LS-44

Federal Highway Administration

Geometric and Safety Design Group Acceptance Letter LS-44

Supplemental Geometric and Safety Design Group Acceptance
Letter LS-44A

TEST STRUCTURE FOR BREAKAWAY COUPLING

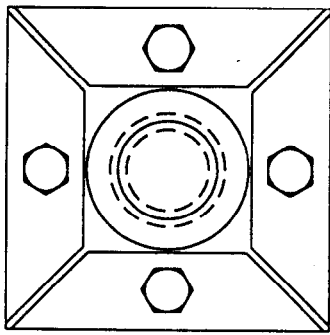
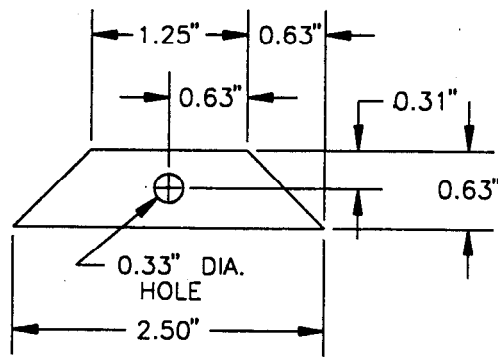
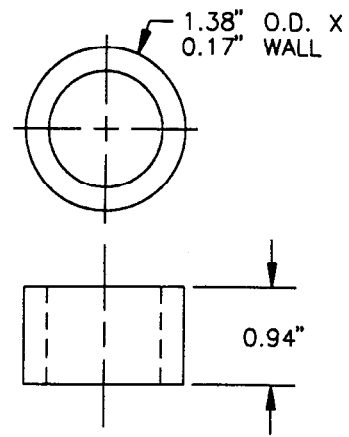
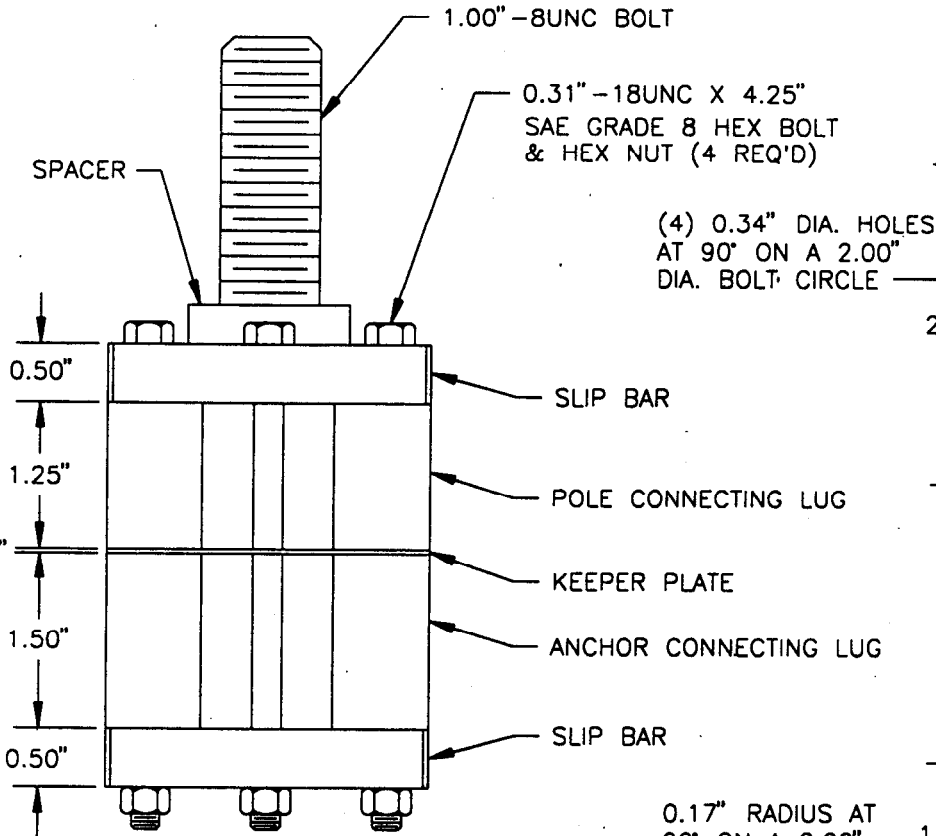
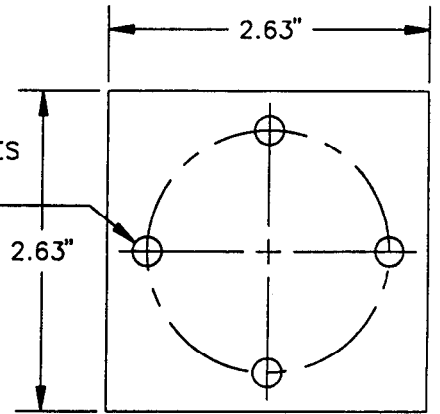
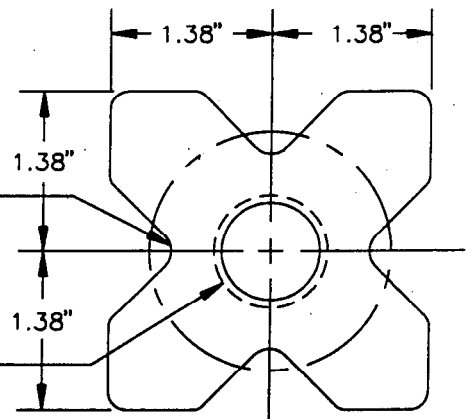
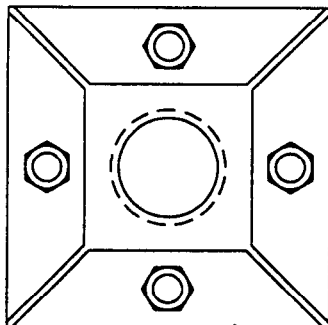
During your visit on April 17, you showed us a video of the crash testing that was conducted to assess the breakaway performance of the prototype couplings. You also showed us examples of the prototype coupling and the coupling as you expect to produce it in the future. As shown in the enclosed drawings of the tested prototype, each of the four couplings supporting the pole is a miniature four-bolt slip base.

The results of the test and the high-speed extrapolation meet the change-in-velocity and stub-height requirements adopted by the FHWA. Your company's breakaway coupling for luminaire supports is therefore acceptable for use on projects on the National Highway System (NHS) where breakaway systems are required if proposed by a State.

We note that the weight of the tested pole was 1017 pounds (461 kg). While this is only slightly over the 1000 pounds (453.6 kg) we have suggested limiting luminaire pole weights to in the past, we believe we must comment on this overage. In the future we will be recommending that the mass of breakaway luminaire and similar supports not exceed a recommended maximum mass of 450 kg (992 pounds) with a maximum plus tolerance of 1 percent, which would set the actual maximum mass at 454.5 kg (1002 pounds).

You also requested our acceptance of a proposed "production" coupling, a modified version of the tested prototype. Since this coupling is of different materials, finish, and size from the tested device, any one of which features could cause a change in test results, we cannot find the proposed breakaway coupling acceptable for use unless qualified through testing.

Our acceptance is limited to the breakaway characteristics of the tested coupling as shown in the enclosed drawings and does not cover its structural features. Presumably, you will supply potential users with sufficient information on design and installation requirements to ensure proper performance. We anticipate that the States will require certification from Valmont that the hardware furnished has essentially the same chemistry, mechanical properties, and geometry as that used in the crash testing and that it will meet the FHWA change in velocity requirements.

BREAKAWAY COUPLING

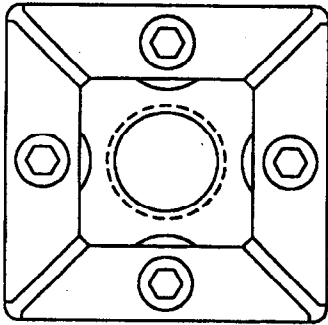
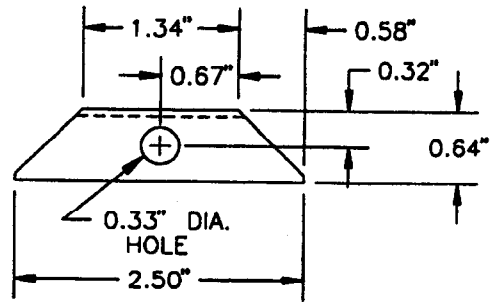
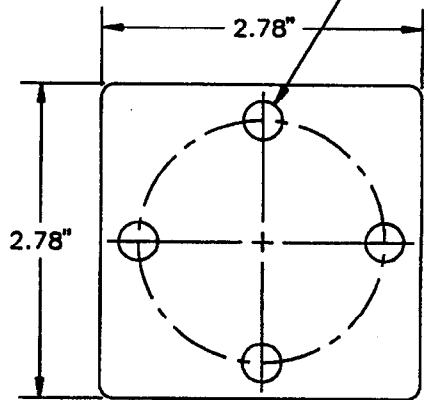
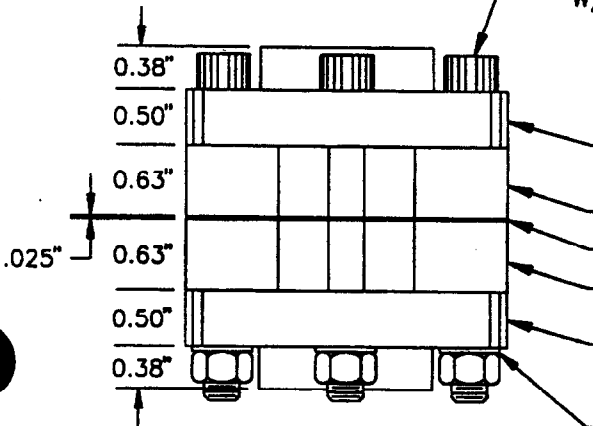
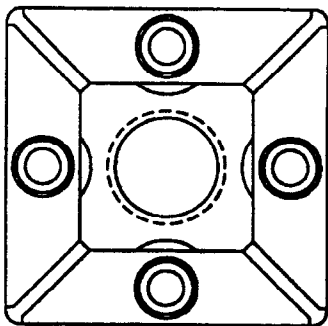
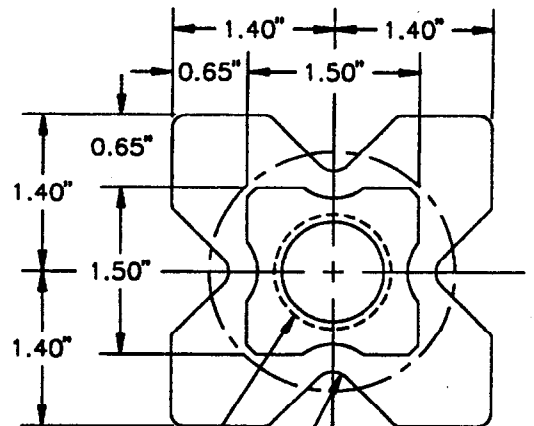
This is in response to your March 3 letter to Mr. Nicholas A. Artimovich, II, in which you requested Federal Highway Administration's acceptance of a change in the fastener hardware used in your company's breakaway coupling design for use with luminaire supports. The coupling with original hardware, shown in the enclosed drawing with the new hardware, was found acceptable in our letter LS-44A dated February 24 and used SAE Grade 8 fasteners. Your request is to substitute ASTM A574 fasteners for the originally accepted fasteners. These substitute fasteners have a 20 percent higher tensile strength than the original. You indicate that this change will increase the load capacity and fatigue strength of the coupling.

Because *of your* manufacturing and quality control procedures, this change in fasteners will have no effect on the clamping force they exert and, thus, no effect on the breakaway performance of the Valmont coupling, we find that such a substitution will be acceptable. All other conditions in our previous letter, referenced above, regarding the use of the coupling remain in-effect.
